Upper South Creek Advanced Water Recycling Centre – Response to Request for Information 44447594 - Flooding

11 July 2022

Attachment A Alignment with NSW Government flood modelling

To	Nat Swannack	From	Peter Gillam
Copy	Elissa Howie, Stephanie Clarke	Reference	
Date	8/07/2022	Pages (including this page)	17
Subject	Upper South Creek AWRC EIS –alignment with NSW Government flood modelling

Figure 3 Comparison between existing case 1% AEP ARR1987 flooding. AWRC TUFLOW results shown with the Government's flood model, Penrith City Council's flood model (WorleyParsons, 2015) and historical markers

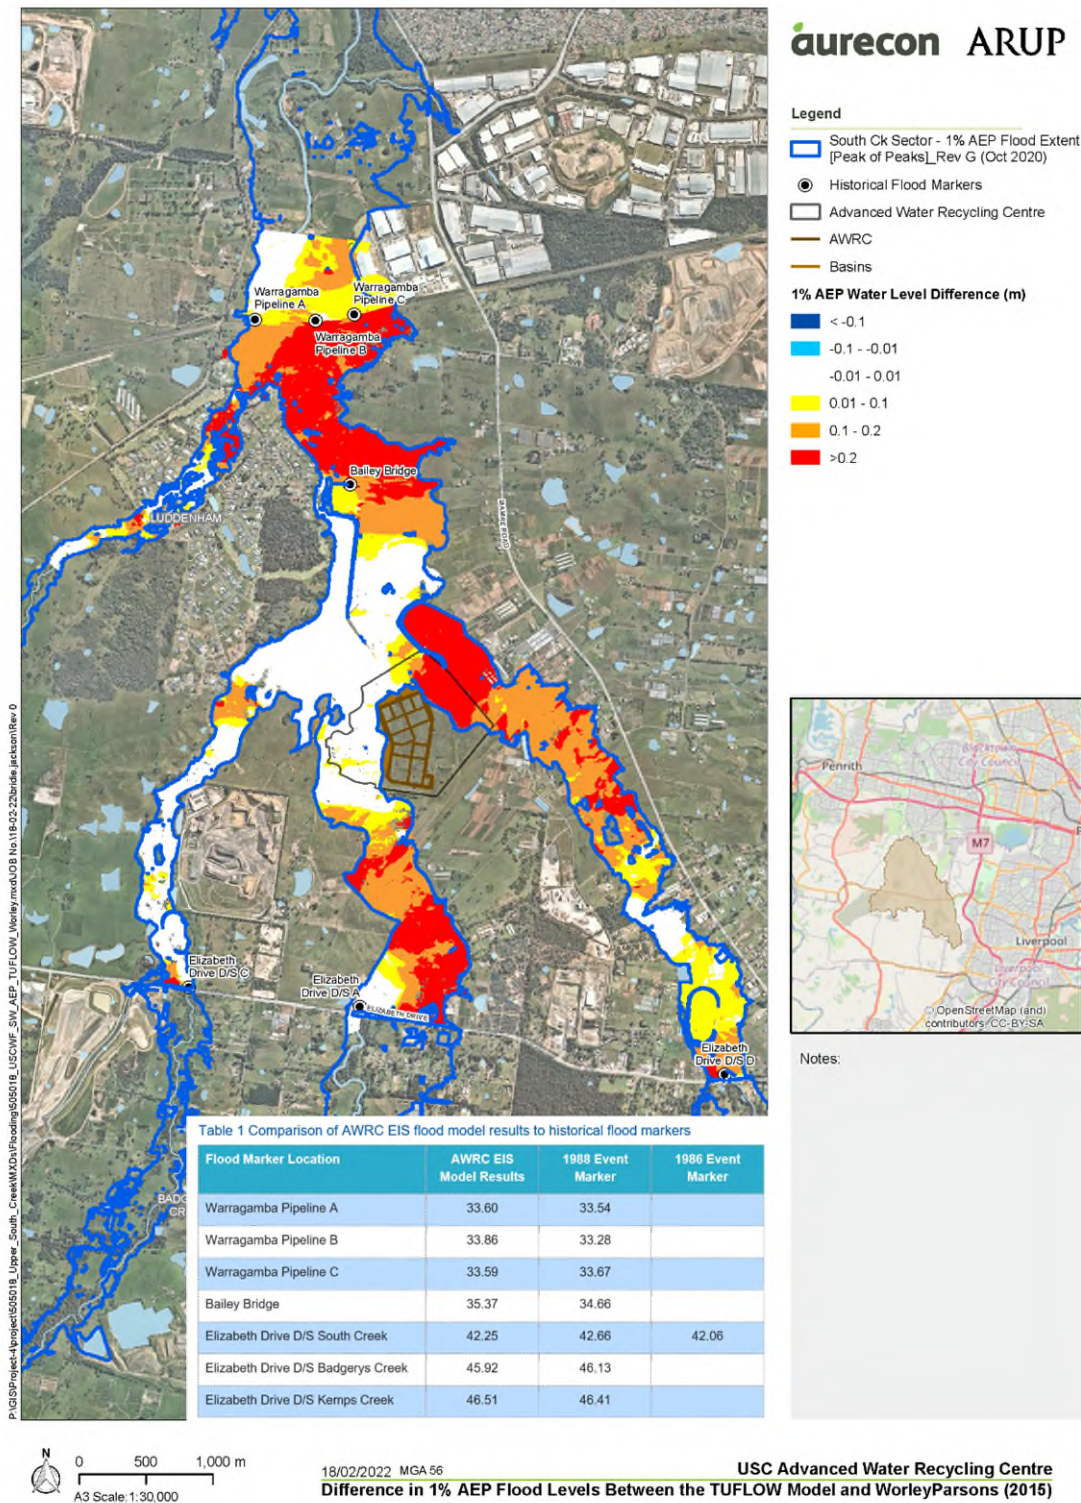
The Request for Information (RFI) notes advice received from the Department of Planning and Environment's Environment and Heritage Group (EHG) requesting Sydney Water to provide further information to clearly explain how the base case (flooding) scenario presented in the project's Flood Impact Assessment (FIA) is compatible with the NSW Government's flood model.

1% AEP flood extent mapping provided by INSW (Flood extent mapping titled South Ck Sector - 1% AEP Flood Extent [Peak of Peaks]_Rev G (Oct 2020)	A comparison between the 1% AEP flood extents shows a good level of agreement with the flood extent predicted by the latest available INSW hydraulic model (blue outline). On this basis, the AWRC EIS hydraulic model results closely match the Government flood model INSW South Creek Sector Review flood extent mapping undertaken in 2020.

On the basis of the three comparisons to the Government's flood data sets provided in Appendix C of the project's Submissions Report, the AWRC TUFLOW model is compatible with Government's flood data including the Government's flood model of existing condition 1%AEP flooding documented in the *Wianamatta (South) Creek Flood Study* prepared for Infrastructure NSW in November 2020.
